Lane Cove Bushland & Conservation Society Inc

SSD-8699 Development of the Greenwich Hospital site, River Road, Greenwich.

Above - discrepancies in the depiction of same site area:

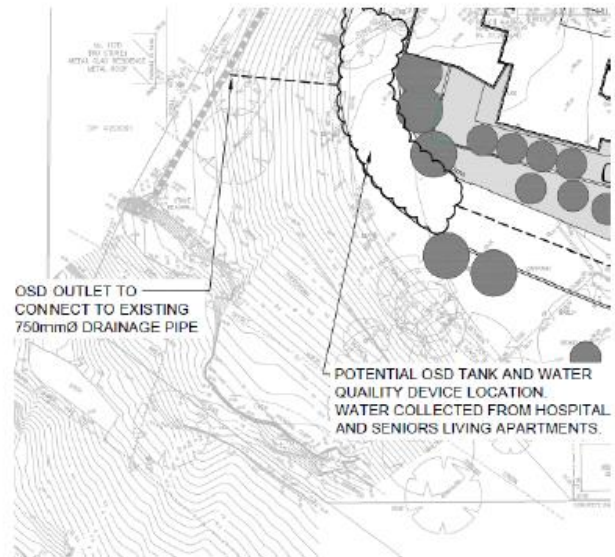
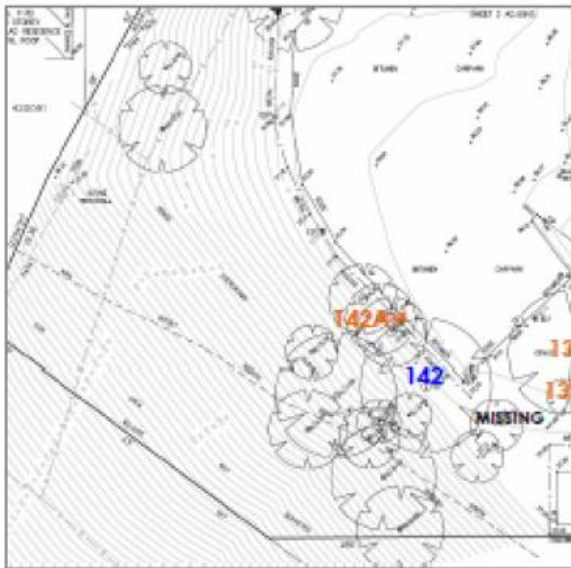
L: Extract p58 of the Arborist Report shows 'interpolated' contours, "Area Not Surveyed", an absence of detail and ignores most existing trees.

R: The Civil Engineering Plan shows the details of contours which accord with reality.

Above - Documents Displaying Different Versions

L: EIS ignores many trees which exist in S-W site corner as in Six Maps Aerial view;

R: The Landscape Plan has ignored the existing topography, bushland and trees and used the inaccurate "area not surveyed" version of contours and trees.
